Access Compliance Report Public Rights-of-Way (RR Crossings)

Intersection ID: 10025412	Main Street: E_CARSON_BV	Location: N/A
ADA ID: 605DE15B4BDE	Overall Compliance: No	Severity Score: 0.0
Codes/Mitigation Info/Possible Solution		Field Measurements/Component Compliance

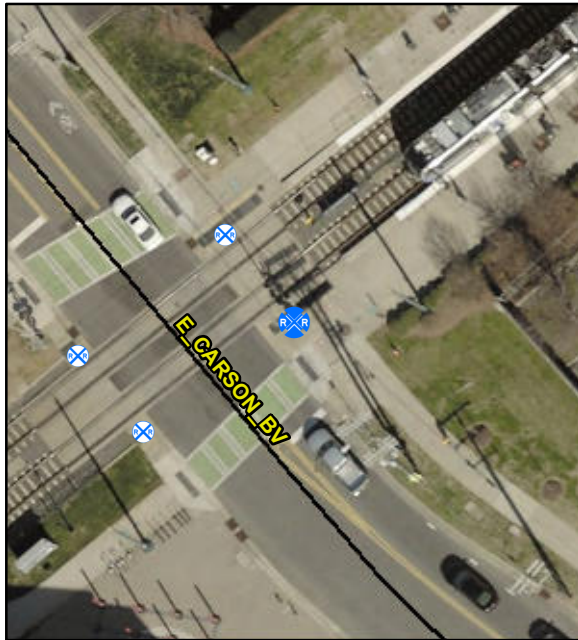
R302.7.4, R305.2.5

Compliance	Description	Data
Yes	DWS Provided?	Yes
Yes	DWS Contrast?	Yes
Yes	DWS Width (in)	Yes
Yes	DWS Length (in)	36.0
No	DWS Offset (in)	29.0
No	Pedestrian Gate?	No
N/A	DWS Outside Gate?	No
N/A	Rail Type?	LightRail
No	Flangeway Gap (in)	3.0
Yes	Sidewalk Width (in)	96.0

Remove & Replace Detectable Warning System. Provide Pedestrian Gate. Remove & Replace Walking Surface Adjacent to Rail.
